PROPOSED RESIDENTIAL DEVELOPMENT, BIRDY BROW, CHAIGLEY, CLITHEROE HIGHWAYS NOTE (V3) - NOVEMBER 2025

Eddisons have been instructed by Mr David Dennis to advise on the transport and highways matters relating to a planning application for a replacement dwelling at Kemple Down, Birdy Brow in Chaigley, Clitheroe.

DRAWING NUMBER:	5017-F02	REVISION:	C
-----------------	----------	-----------	---

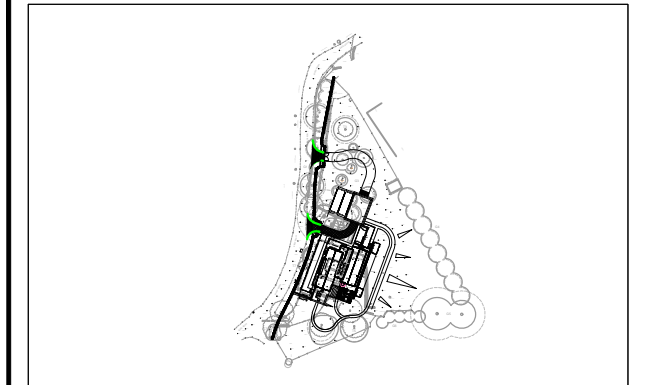
While the LHA has previously accepted reduced splays of 59 metres north and 65 metres south based on observed vehicle speeds and the safety record of existing accesses, it cannot support any further reduction, particularly at a new location with no established safety record.

The LHA therefore recommends that the applicant submit an amended plan relocating the proposed access further from the bend and achieving visibility splays of at least 59 metres to the north and 65 metres to the south'.

- Entrance only access at the previously proposed two-way access location, i.e. approximately 28 metres to the south of the bend in the road;
- Egress/exit only from the approximate location of the existing (northern) access; and
- Closure of the existing (southern) access, as previously proposed.

The revised access proposals are shown in **Drawing ref no. 5017/F02 Rev A**.

In accordance with the dimensions specified by LCC above, the proposed egress, can achieve visibility splays of 59 metres north and 65 metres south. As advised by LCC *'These splays are based on observed vehicle speeds and the safety record of existing accesses'*.

project	project number	drawing number
Kemple Down	23.61	PL.07
name	proposed highways plan	
scale	date	status
1:100 and 1:1250 @ A1	february 2025	planning application
revision	A

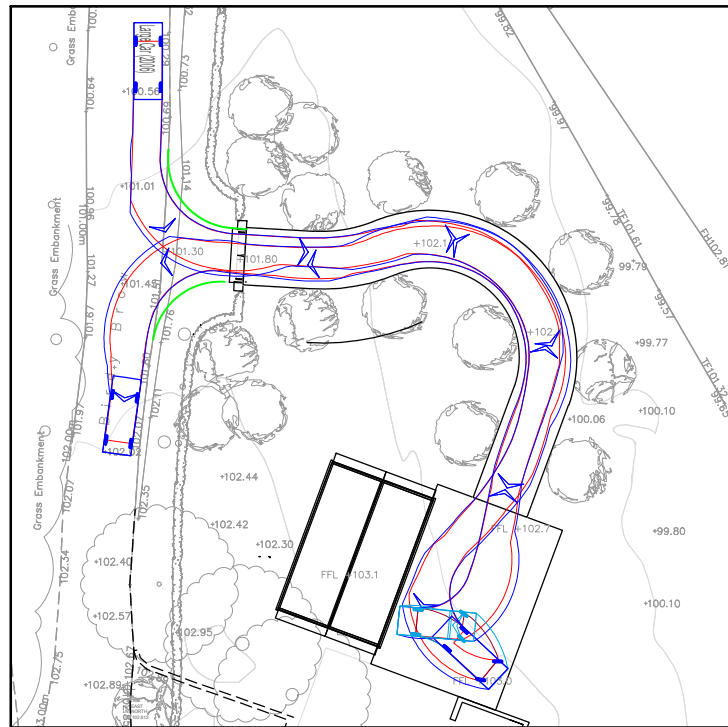
In conclusion, the officer advised that *'the current proposal to remove the southern access raises concerns due to its superior visibility compared to the retained access. To address these concerns, it is imperative that the applicant submits a detailed visibility splay drawing that clearly delineates the maximum achievable splay in both directions'*.

A plan to show the maximum achievable visibility splays was provided in **Drawing ref no. 2361 PL07 Revision A** and is included in this Note for ease of reference. The plan shows that based on the location of the proposed access point, visibility splays of 59 metres to the north and 65 metres to the south could be achieved.

In regard to the visibility splays detailed above, the officer acknowledges Drawing PL07 Revision A and notes that it *'shows a visibility splay and whilst this does not meet the posted national speed limit, on-site observations noted lower vehicle speeds given the sites location close to natural bends within the road. There is also no footways or street lighting which will also contribute to lower speeds along the road'*.

DRAWING NUMBER: **5017-F01** REVISION: **-**

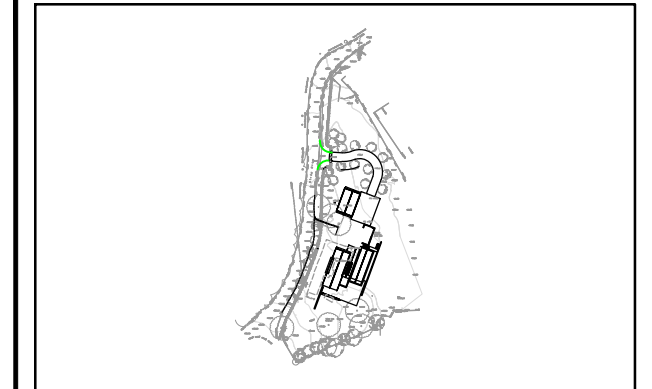
The LHA has concerns over the proposed access point due to its positioning near a natural bend in the road, which raises highway safety concerns. The existing access point, which currently sits closest to the bend, is situated approximately 58m from the bend, whereas the proposed access point will be positioned approximately 28m from the bend. The LHA does not support locating access points on or near bends due to highway safety concerns because of limited visibility of those exiting the access and through traffic on the network and the increased potential for conflict.

The proposed access visibility splay also has a significant shortfall in what would be expected for a national speed limit road. Normally, the LHA would look for an access on a national speed limit road to have a visibility splay of 2.4m x 214m. The proposed site plan, Drawing PL.20, shows a visibility splay set 2.4m back for 37 metres to the North and 65 metres to the South of the access. The visibility splay to the North has however, been offset away from the carriageway edge; as such the LHA's view is that the visibility splay to the north is approximately 35.5m without being offset.

As such, the LHA cannot support the current proposal and would urge the application to provide an amended plan which provides an access placed further from the bend in the road and has a visibility splay for at least 59 metres to the north and 65 metres to the south.

As can be seen on the plan, the access currently proposed can achieve the following visibility splays:

- 2.4 metres x 36.7 metres to the north; and
- 2.4 metres x 65.0 metres to the south.

Clearly, the southern visibility splay accords with the distance required by LCC, however, as the new access is now situated further north, the visibility distance available is reduced to 37.6 metres.

Whilst below the 59 metres previously considered acceptable, it is Eddisons view that the access is justified, would still operate in a safe and efficient manner and would not give rise to any highway safety issues.
